ADMINISTRATIVE AMENDMENT

AMENDMENT AUGUST 24, 2021

GUARDIAN STORAGE
OSUNA ROAD

SITE PLAN - DRB

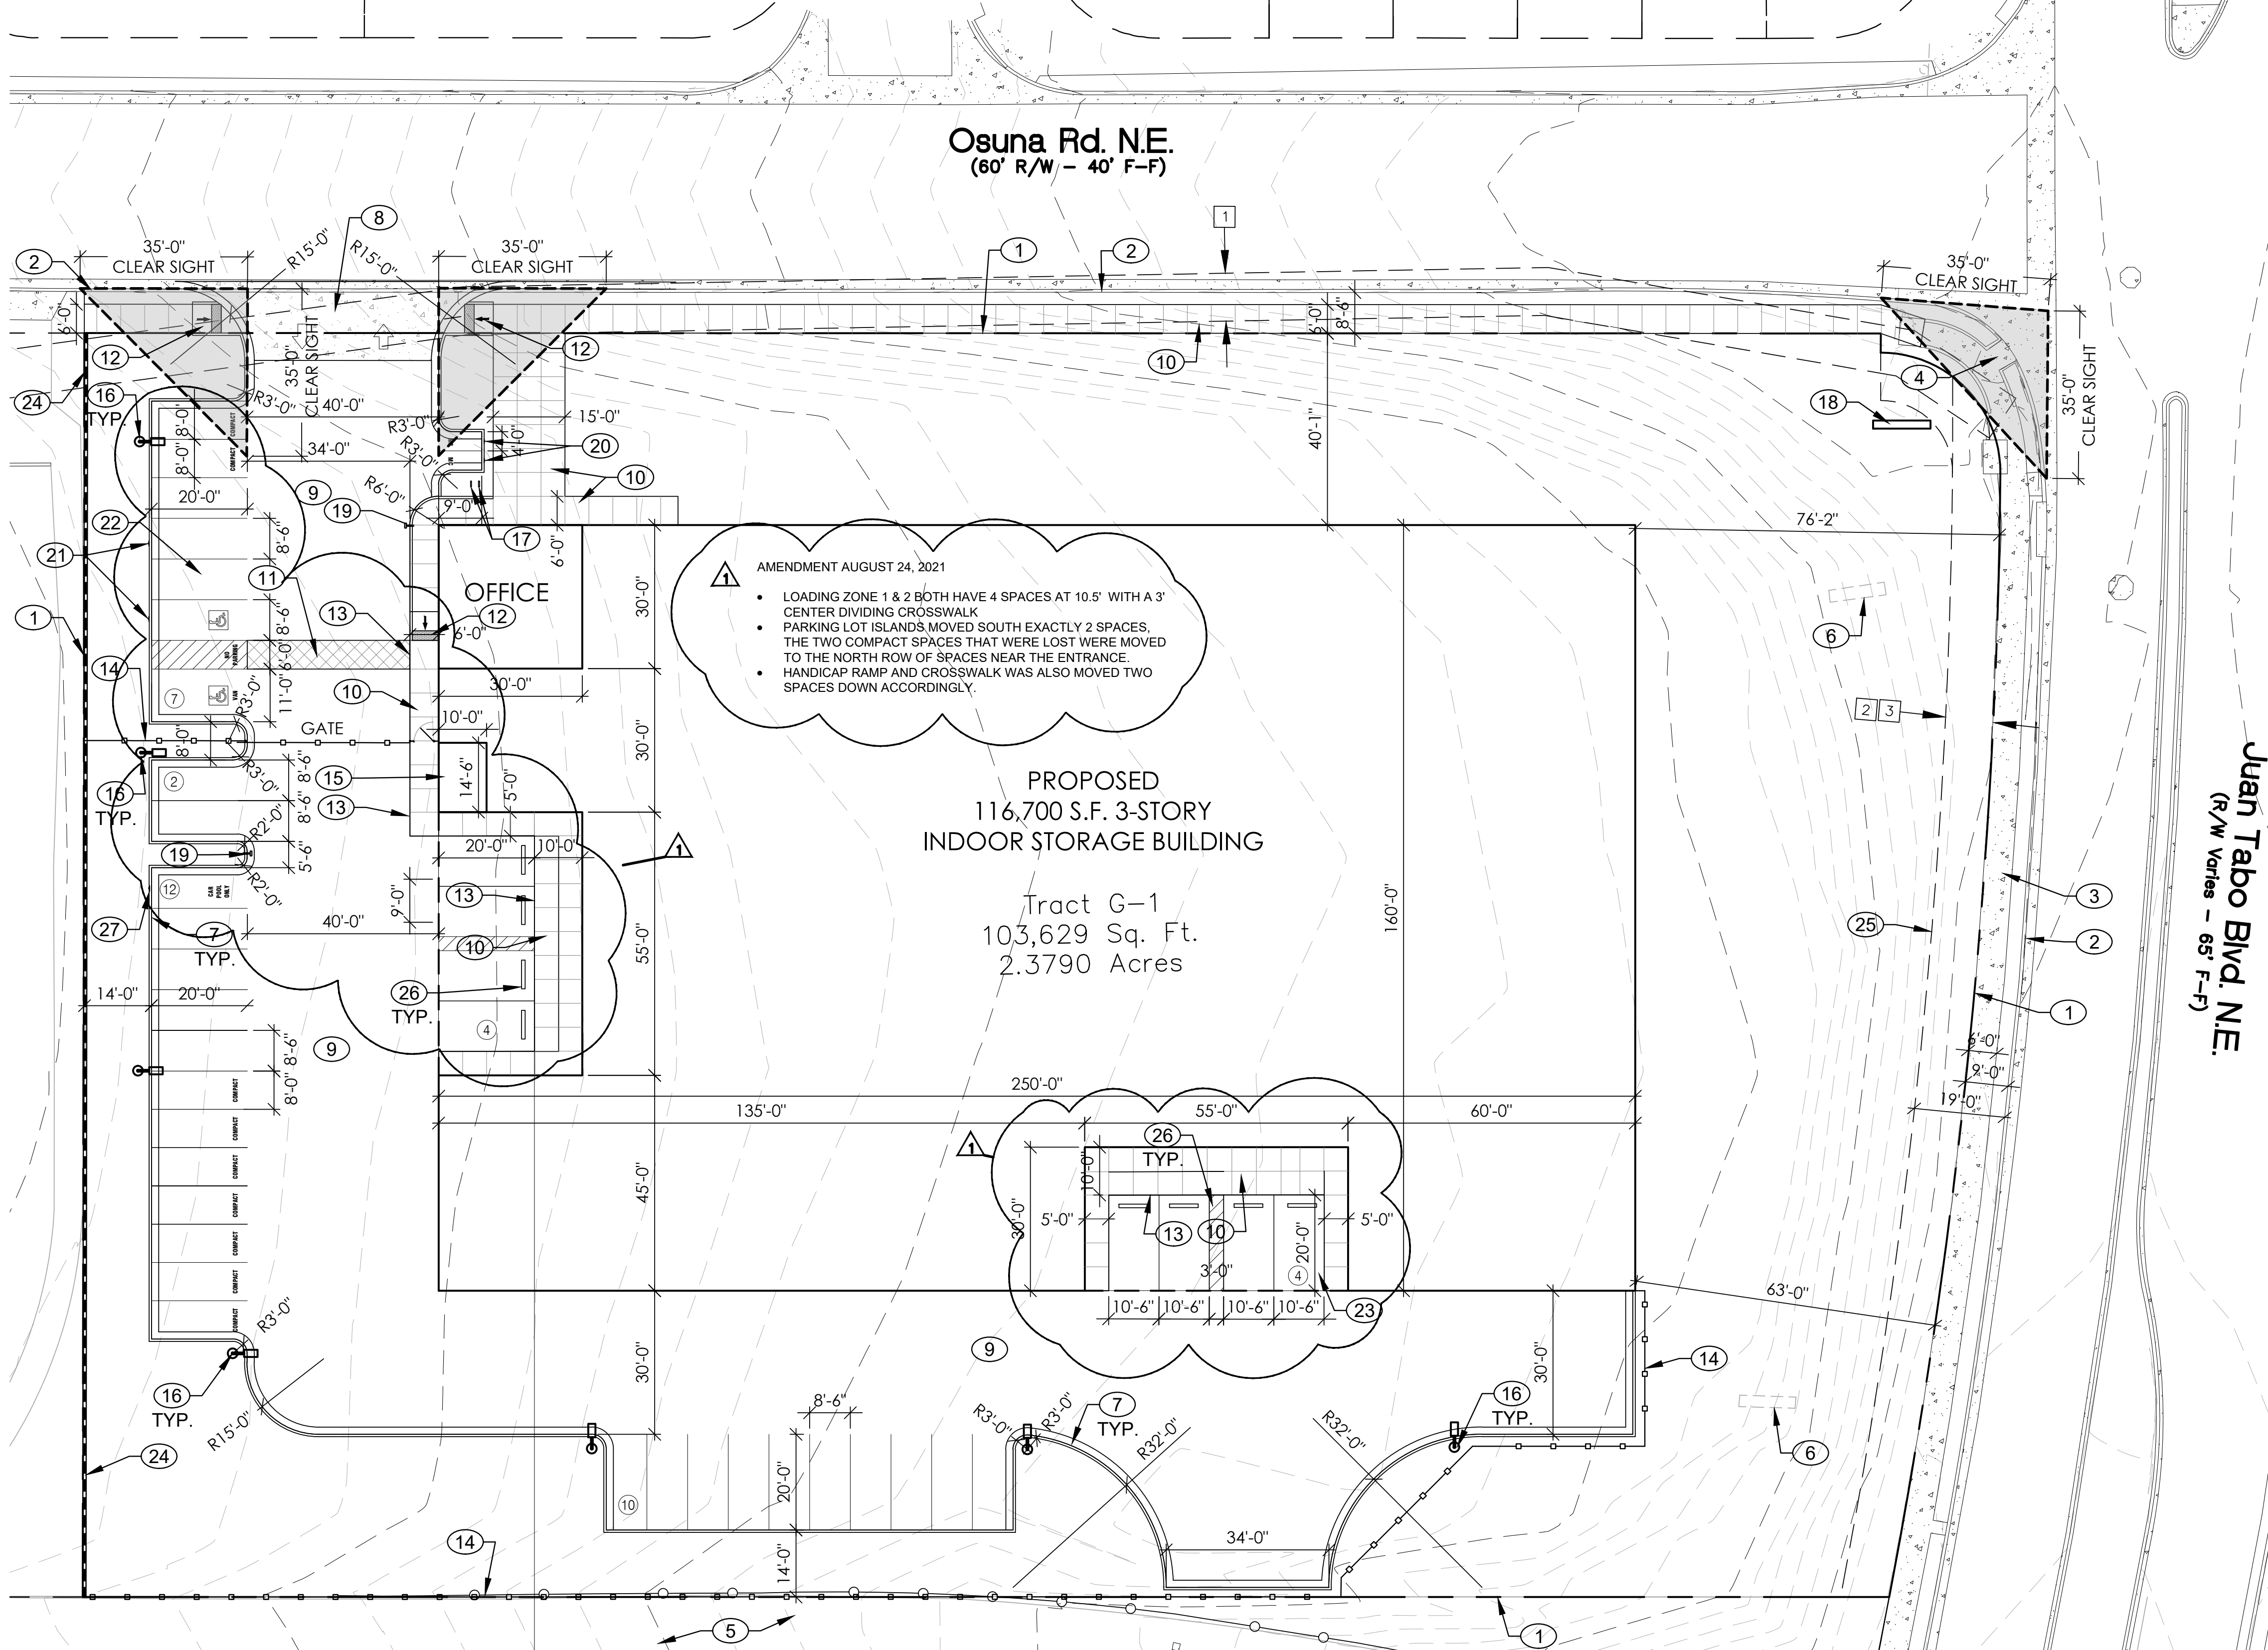
- LOADING ZONE 1 & 2 BOTH HAVE 4 SPACES AT 10.5' WITH A 3' CENTER DIVIDING CROSSWALK
- PARKING LOT ISLANDS MOVED SOUTH EXACTLY 2 SPACES. THE TWO COMPACT SPACES THAT WERE LOST WERE MOVED TO THE NORTH ROW OF SPACES NEAR THE ENTRANCE.
- HANDICAP RAMP AND CROSSWALK WAS ALSO MOVED TWO SPACES DOWN ACCORDINGLY.
